1636 Argonne Place, NW Existing Conditions

Front Elevation & Grade

FRONT GRADE - Revised Plans, Proposed – East Elevation
Sheet A0201 (12/17/14)

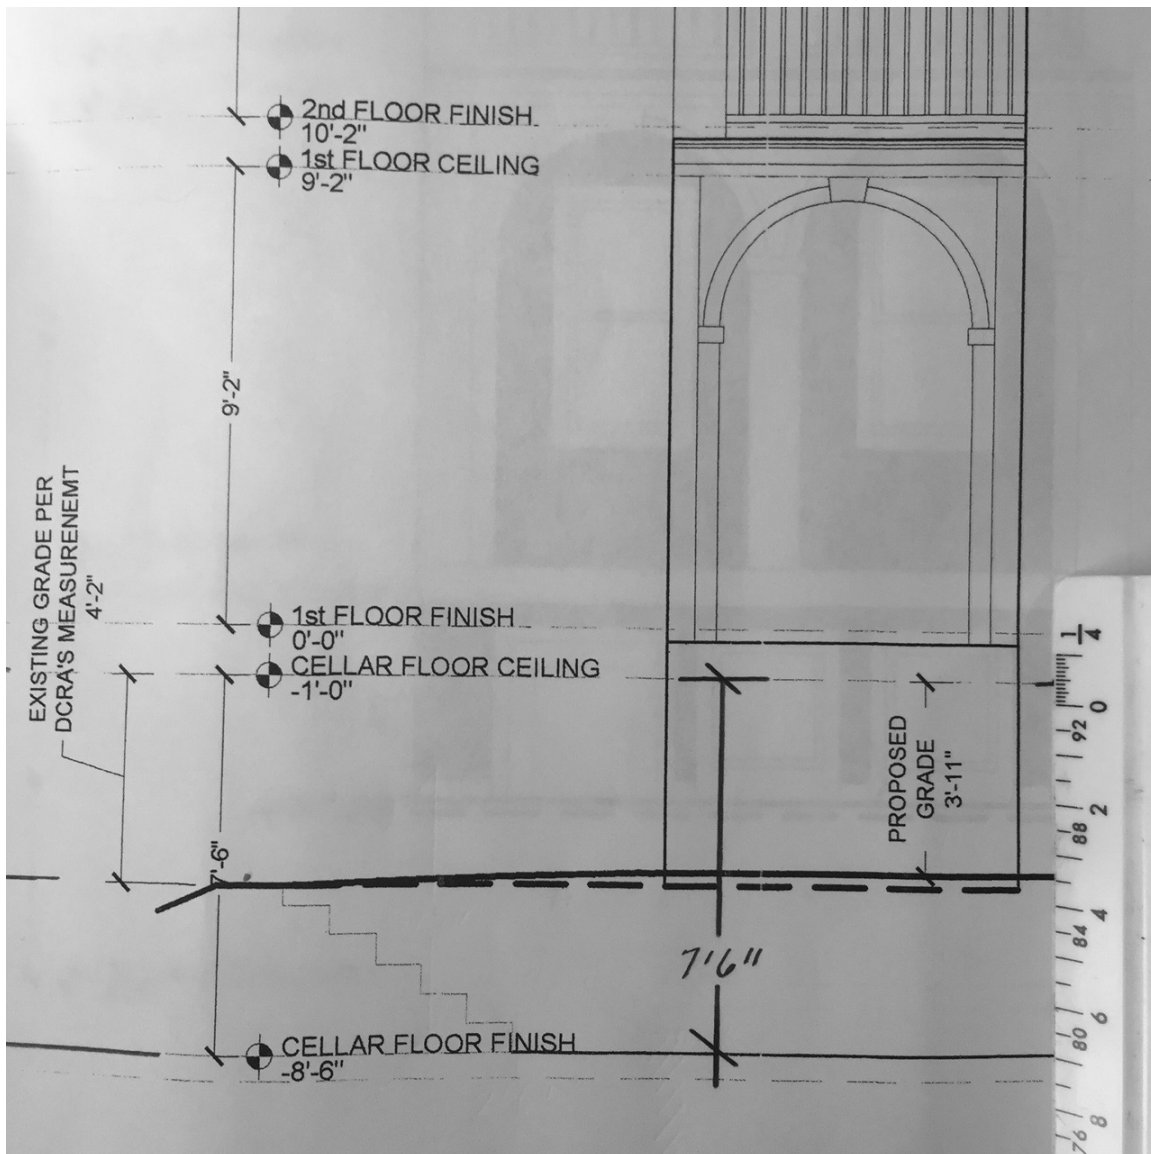
DCRA Notes Existing Grade as 4'2"
This Establishes Lower Level Front Grade as Basement
Drawing Misrepresents Grade as 3'11"

FRONT ENTRYWAY - Revised Plans, Proposed
A0100 (12/17/14)

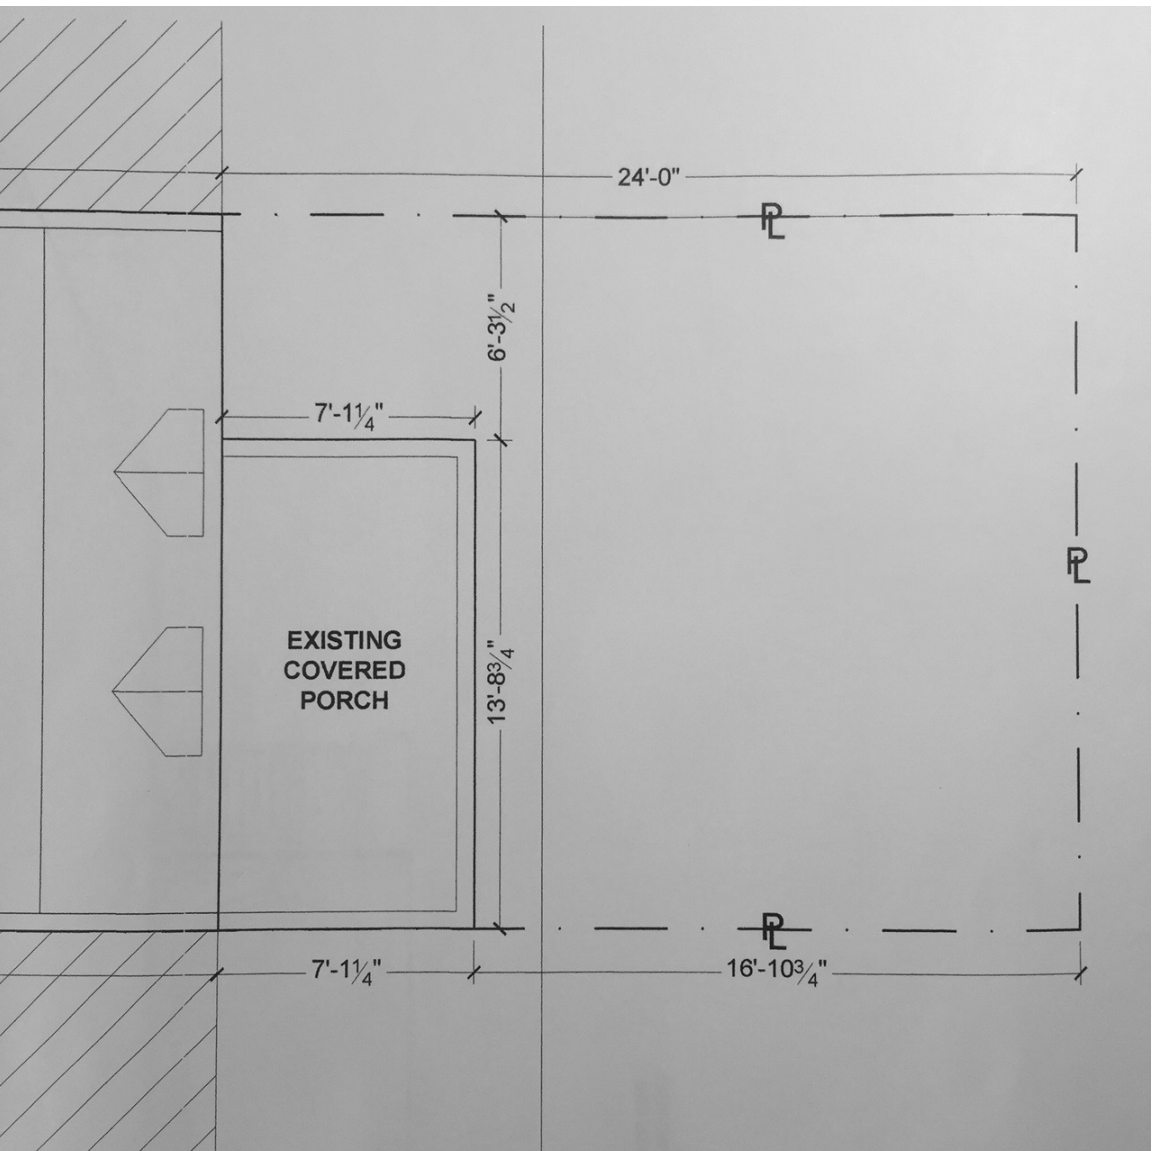
Entryway at Lower Level is 7 ¼ Width, 7" 6" Grade
Entryway is NOT Definable as Areaway and is Proper Point of Measurement

REAR GRADE- Revised Plans, Proposed - East Elevation
Sheet A0201 (12/17/14)

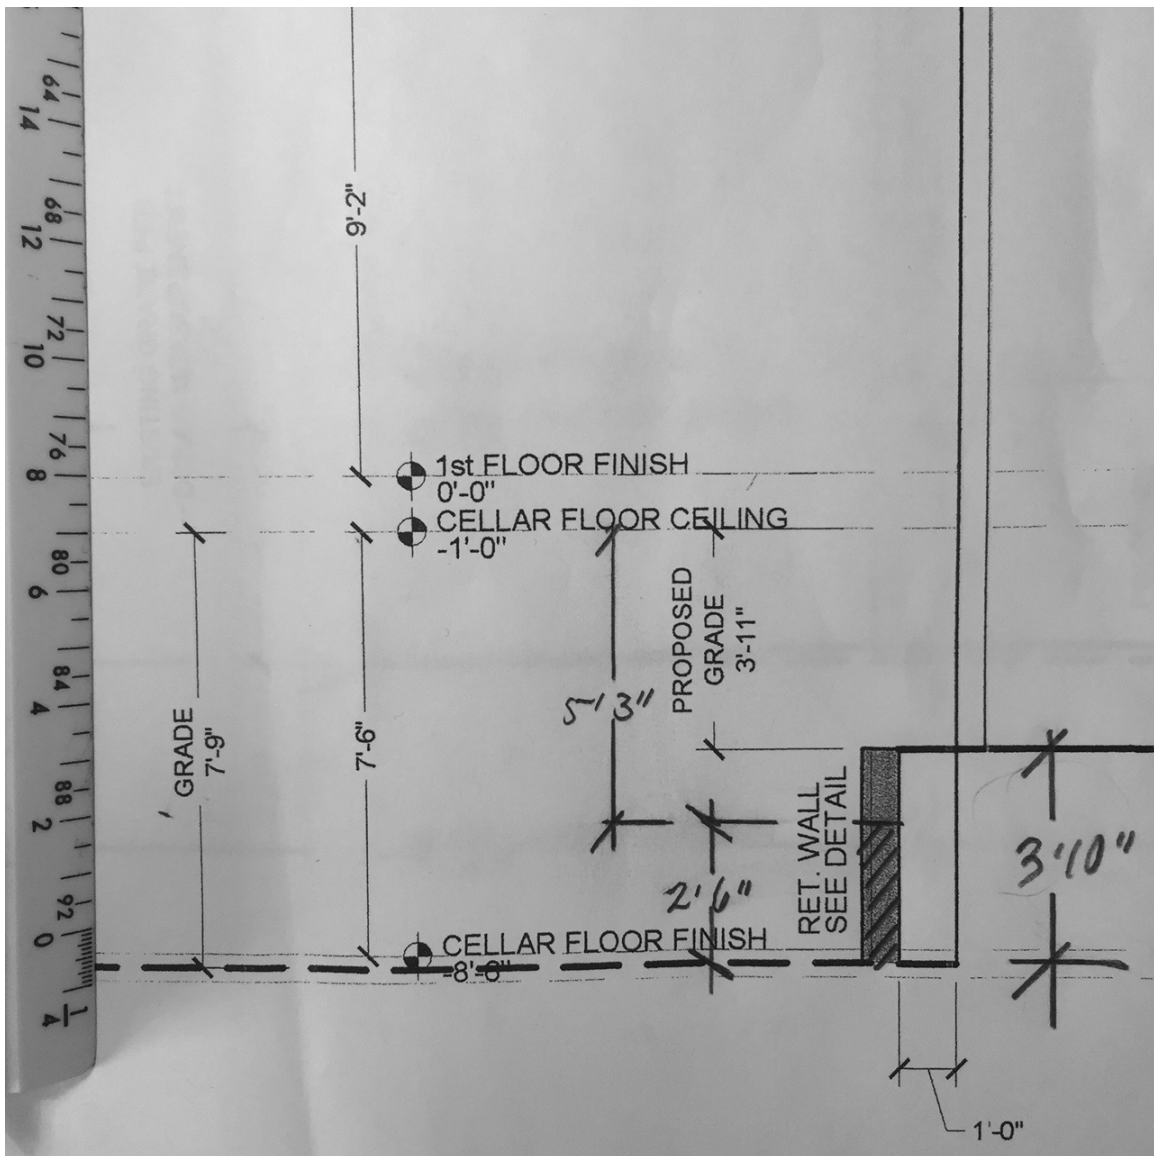
Existing Grade is 7'6", Establishing Rear as Basement Grade
Drawing Misrepresents Retaining Wall as 3'10"
Grade Would be 5'3" if Constructed at Permitted 2' height

REAR GRADE – Revised Plans, Proposed – West Elevation
Sheet A0202 (12/17/14)

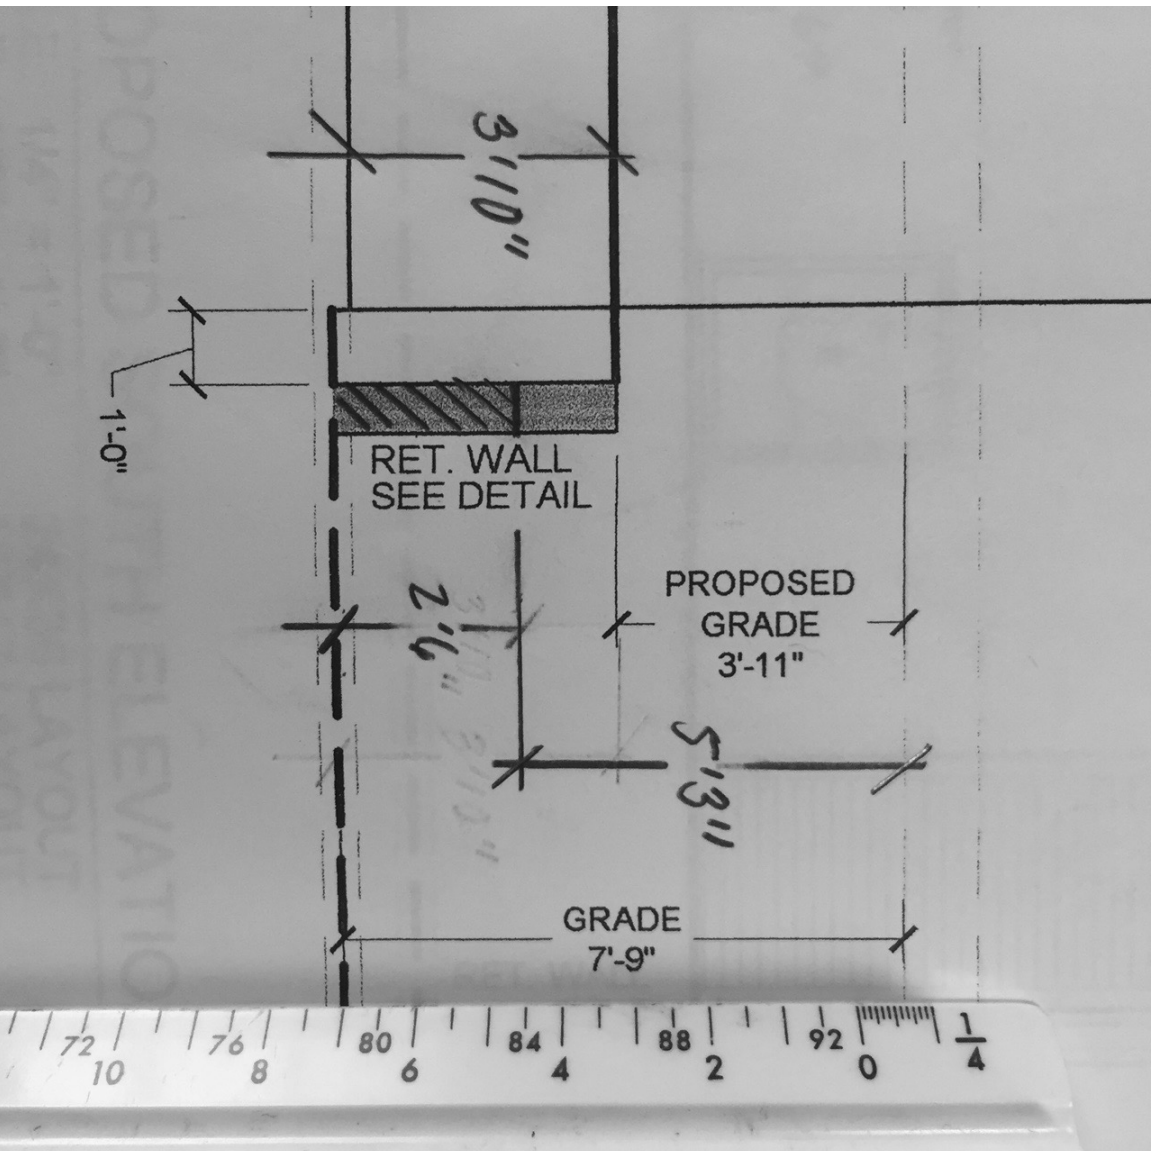
Existing Grade is 7'9", Establishing Rear as Basement Grade
Drawing Misrepresents Retaining Wall as 3'10"
Grade Would be 5'3" if Constructed at Permitted 2'6" Height

PARKING – Revised Plans, Proposed
Sheet A0100 (12/17/14)

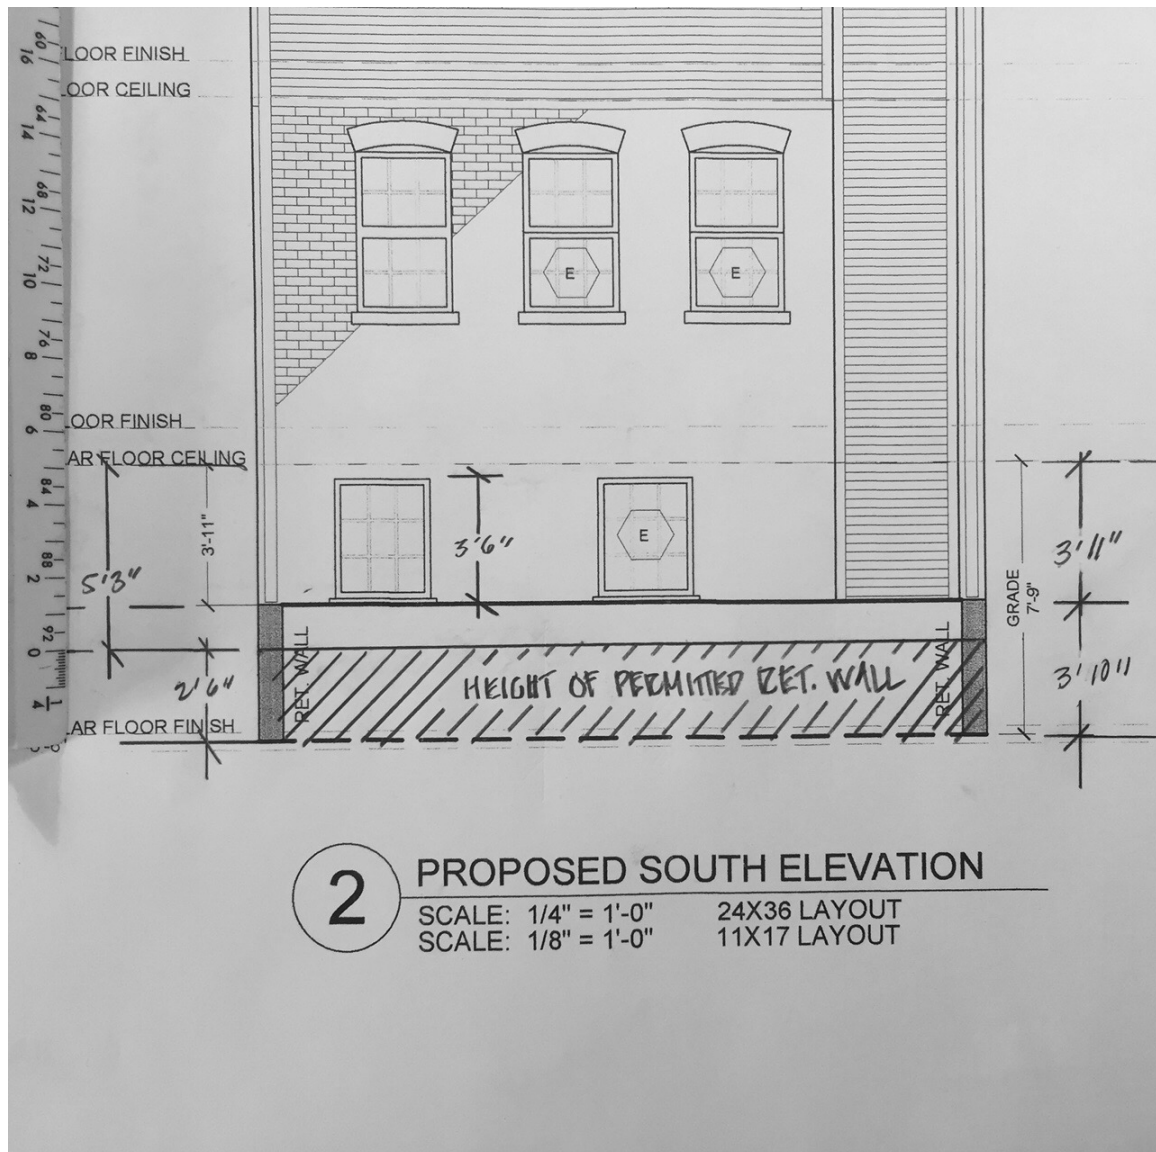
Current Parking Area is 16' Deep, Insufficient for 19' Regulation Spaces
Retaining Wall Would Further Shorten Depth to 14'4"
This Worsens Already Non-Compliant Condition, Making Parking Impossible
